**SAN ANTONIO INTERNATIONAL AIRPORT
EVID SYSTEM
UPGRADE
9800 AIRPORT BLVD.
SAN ANTONIO, TX 78216**

REVISIONS:	DATE:	
ADDENDUM #4	07/22/2021	
SHEET TITLE:		
EVIDS PLAN TERMINAL A DEPARTURE LEVEL AREA 04		
SHEET		
AV.2.2.04		
DATE:	04/26/2021	
DRAWN	DESIGNED	CHECKED
DM	BS	BS

1
EVIDS PLAN
TERMINAL A DEPARTURE LEVEL AREA 04
0 8' 16' 32'

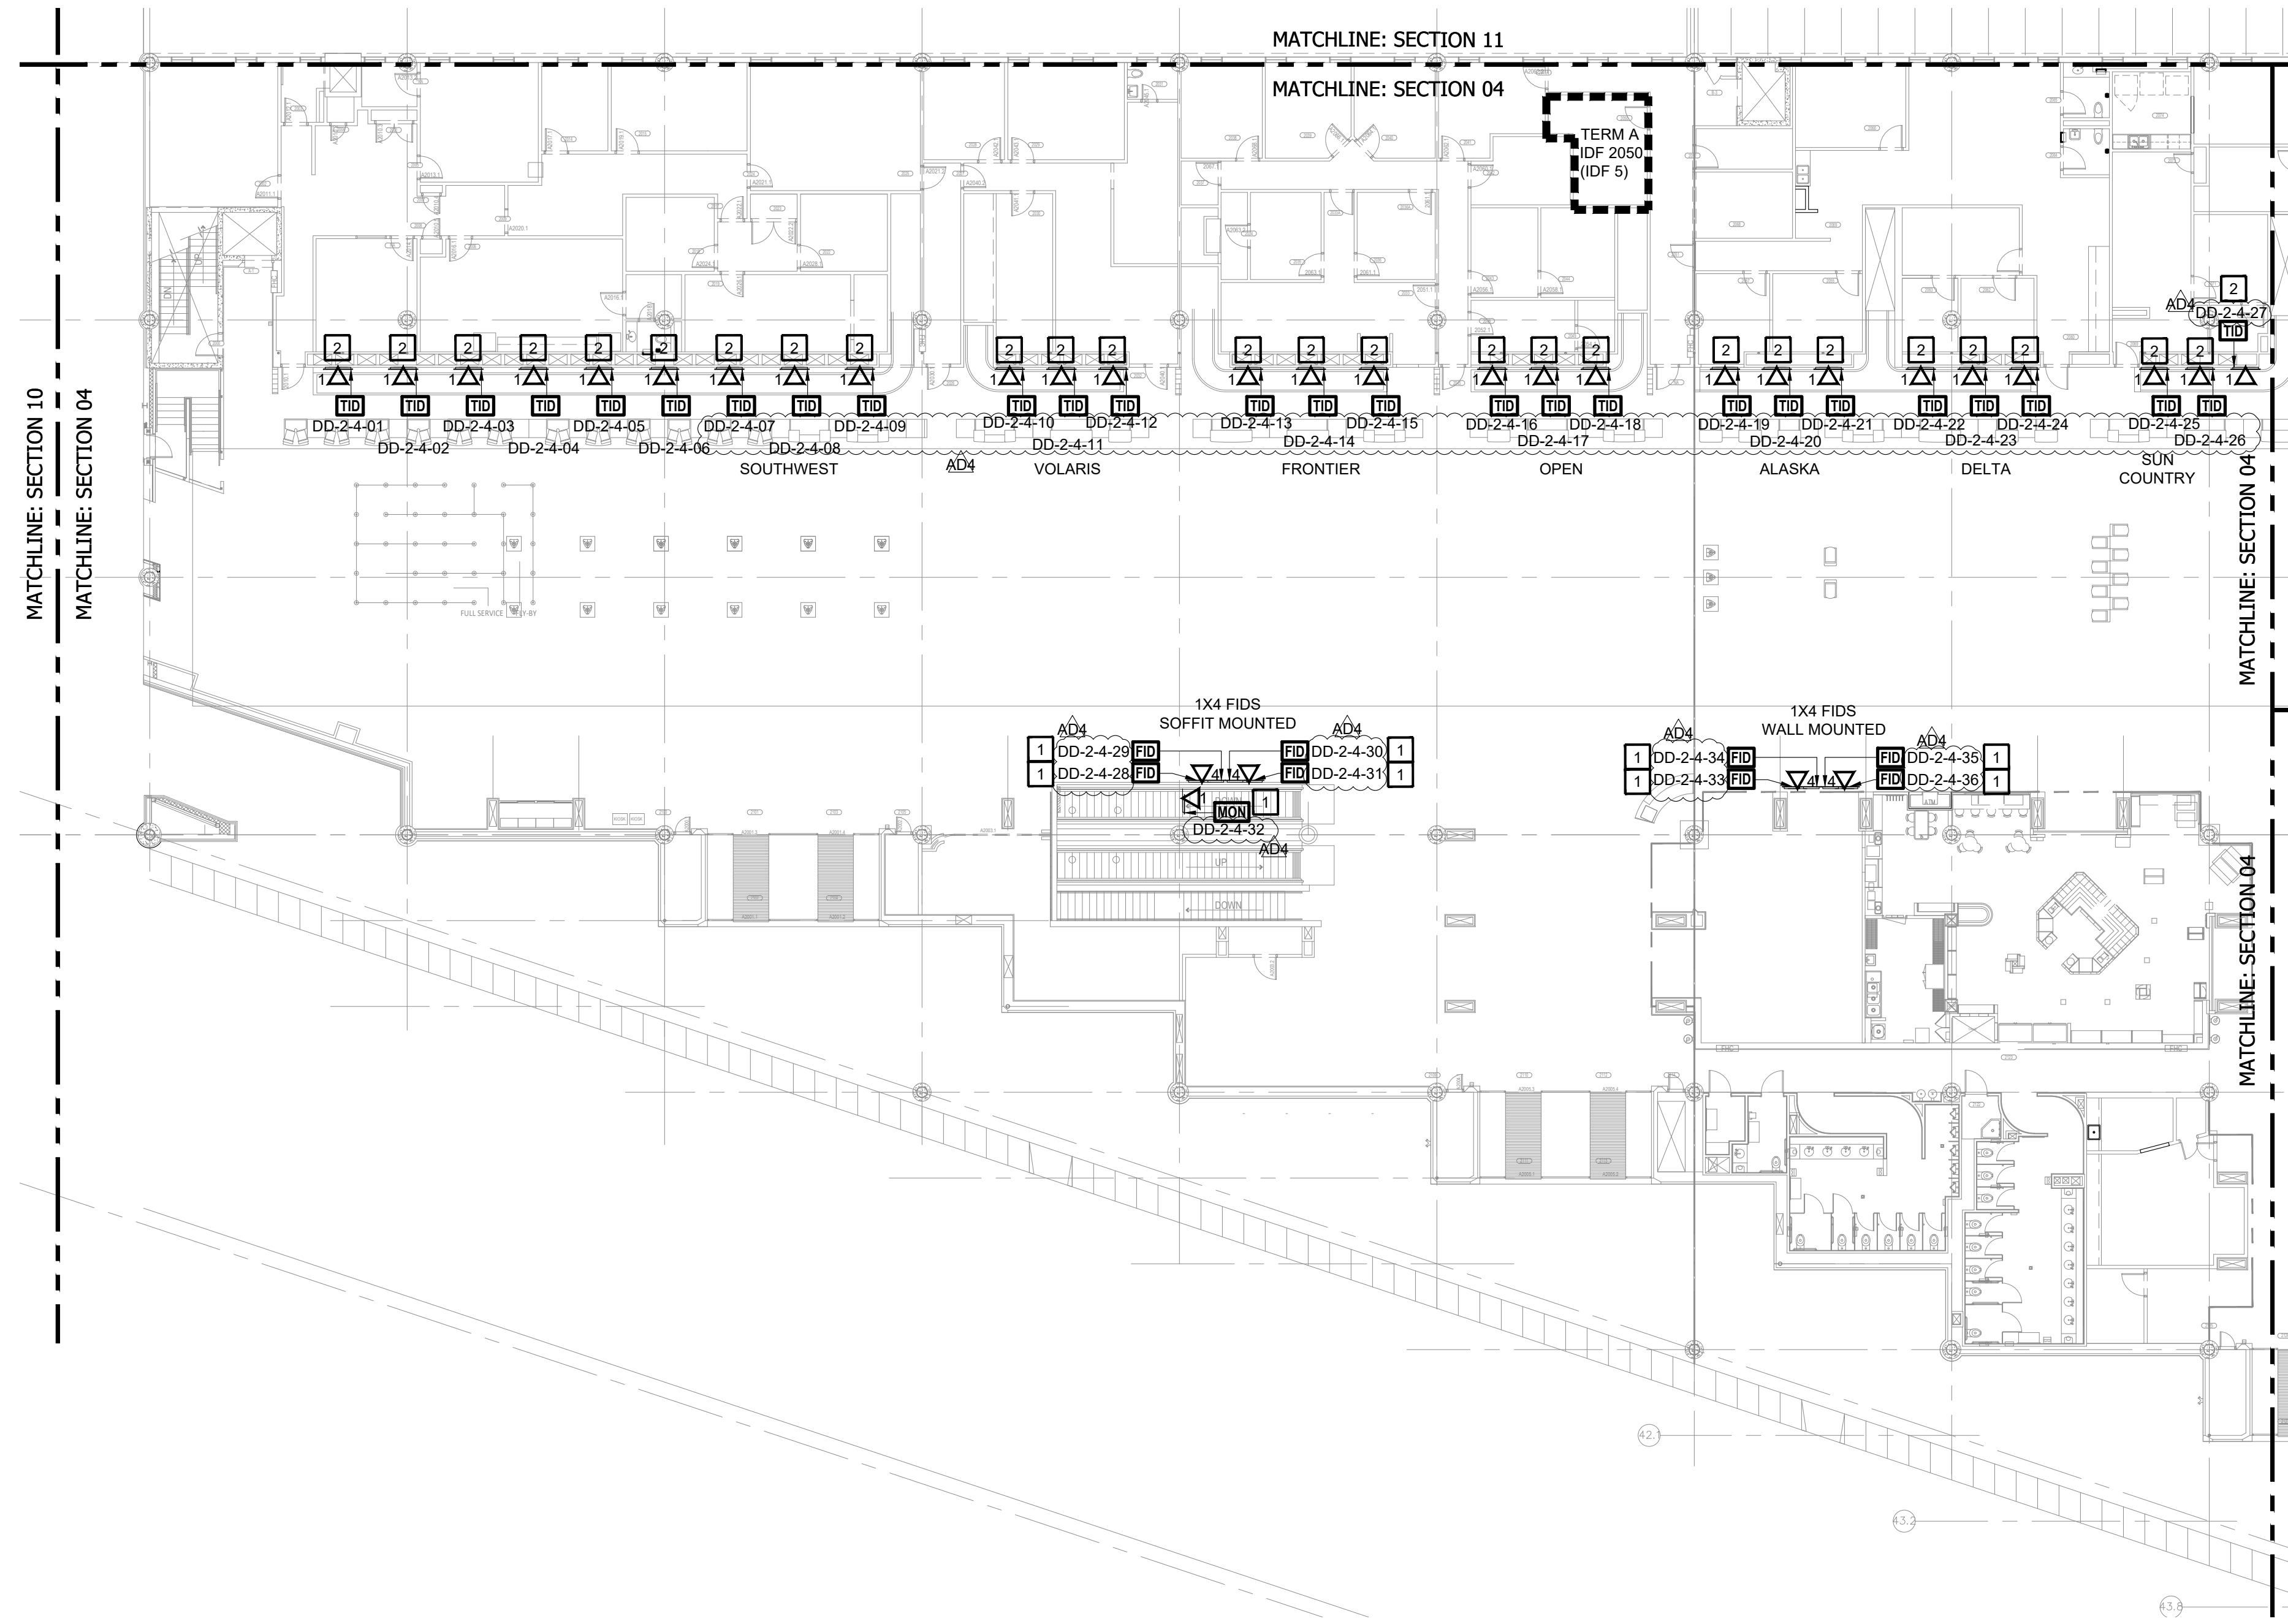
- 1 REMOVE EXISTING DISPLAY AND DDC. REPLACE WITH NEW MONITOR AND DDC. USE EXISTING MOUNT FOR NEW DISPLAY. SECURE DDC TO BACK OF MONITOR. USE CABLE MANAGEMENT AS NECESSARY TO PROVIDE CLEAN WORKMANSHIP.
- 2 REMOVE EXISTING DISPLAY, DDC AND MONITOR MOUNT. REPLACE WITH NEW MONITOR, DDC AND MOUNT. SECURE DDC TO BACK OF MONITOR. USE CABLE MANAGEMENT AS NECESSARY TO PROVIDE CLEAN WORKMANSHIP.
